Complaint Ref: KH/CAS-123091-Y3J7R2 London Borough of Croydon - Escalation to the Local Government Ombudsman.

Planning Application Ref: 19/01352/FUL; 56 Woodmere Avenue, Croydon CR0 7PD

Complaint Ref: KH/CAS-123091-Y3J7R2 London Borough of Croydon - Escalation to the Local Government Ombudsman.

Planning Application Ref: 19/01352/FUL; 56 Woodmere Avenue, Croydon CR0 7PD

Graph of TfL Access Index related to Public Transport Accessibility Level (PTAL) [1] at both PTAL 1a (the site) and PTAL 5.403 (as required by the application)

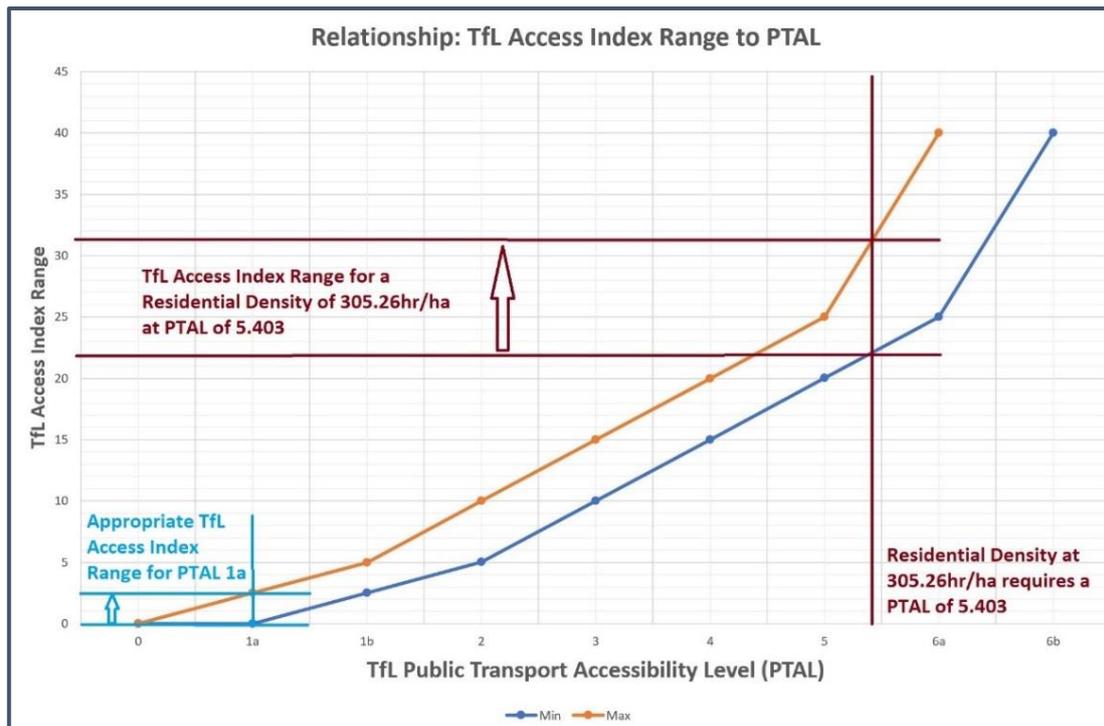
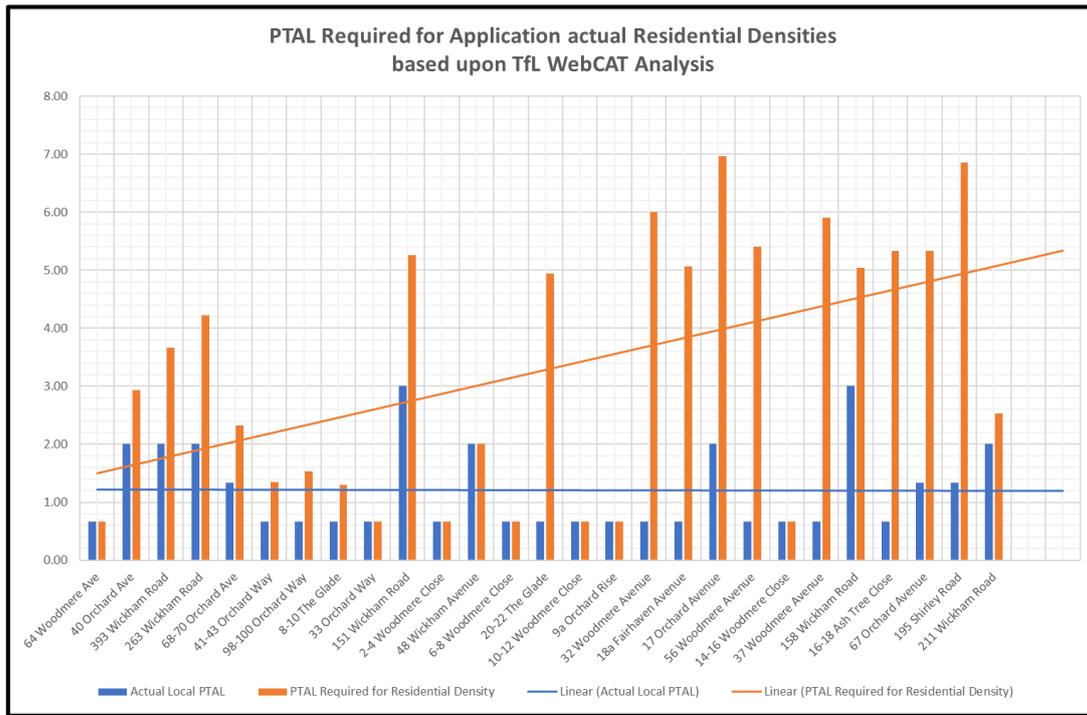
These results clearly show the required **PTAL** to be **significantly higher** than is available at the locality of **PTAL 1a (=0.66)**.

This Table (above) shows the relationship between "PTAL" and the "Access Index Ranges" used by Transport for London. See: TfL WebCAT Conversion from Access Index to PTAL ^[1]

From the foregoing, it is clear that for the **Residential Density of 305.26hr/ha** requires a **PTAL of 5.403** which in turn requires a **TfL Public Transport Access Index in the range ≈ 22 to ≈ 31.5** .

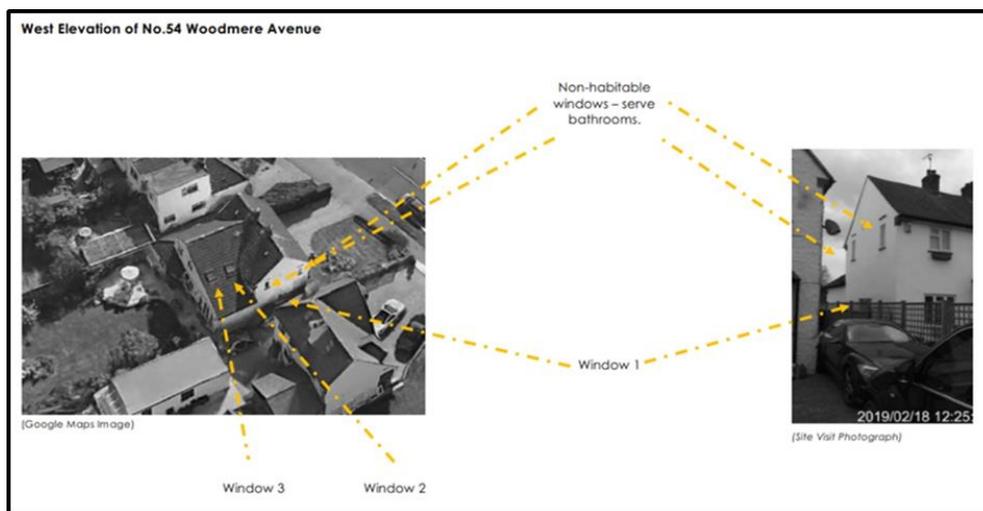
It is exceedingly strange how the “Base Energy” Company, Daylight Report for this proposal, evaluated the Daylight Factor (DF) and provided quantifiable parameters for this analysis when they never entered the property at 54 Woodmere Avenue or requested parameter quantities to quantify the internal features and room parameters of 54 Woodmere Avenue or required the aperture of each of the Habitable Room Windows for their analysis when those parameters are fundamental to the evaluation of the appropriate Daylight Factors (DF).

Applicant’s Erroneous Assessment (See below & Table)

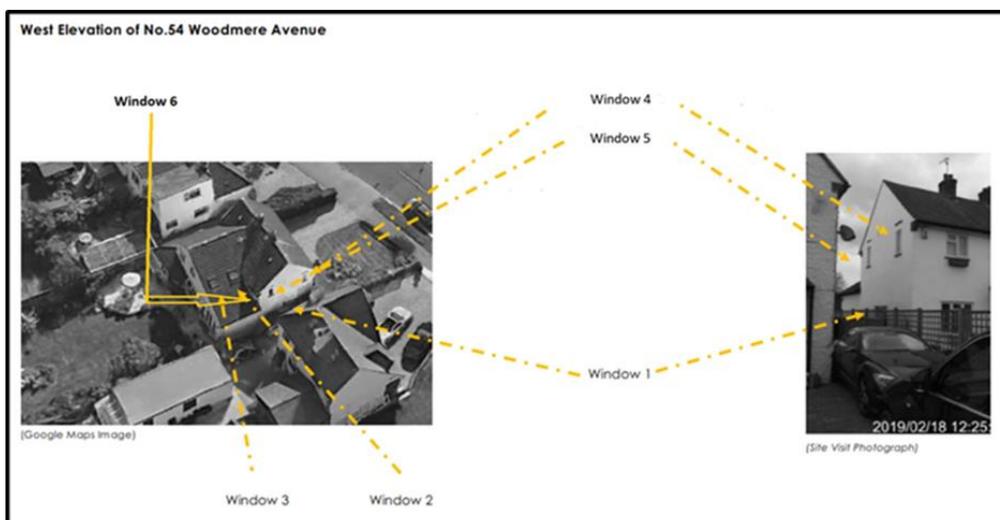
It seems to have escaped Ms. Mustafa’s response, to consider the Applicant’s assessment of Daily Sunlight effects on 54 Woodmere Avenue when they failed to consider all appropriate windows, their areas and internal room dimension. Also, no assessment was made of the impact of changes in the footprint and height in the front elevation of the proposed development on the light available to front windows on the western flank of 54 Woodmere Avenue.

- The applicant had mistakenly designated the windows served; and
- The Daylight Study failed to take account of the small window apertures which restrict natural light into the Habitable Rooms of 54 Woodmere Avenue.
- The Base Energy company failed to gain access to 54 Woodmere Avenue to evaluate all necessary internal room and window parameters to calculate the Daylight Factors (DF's)
- The Base Energy company failed to provide any calculations or evidence of how they arrived at their results.
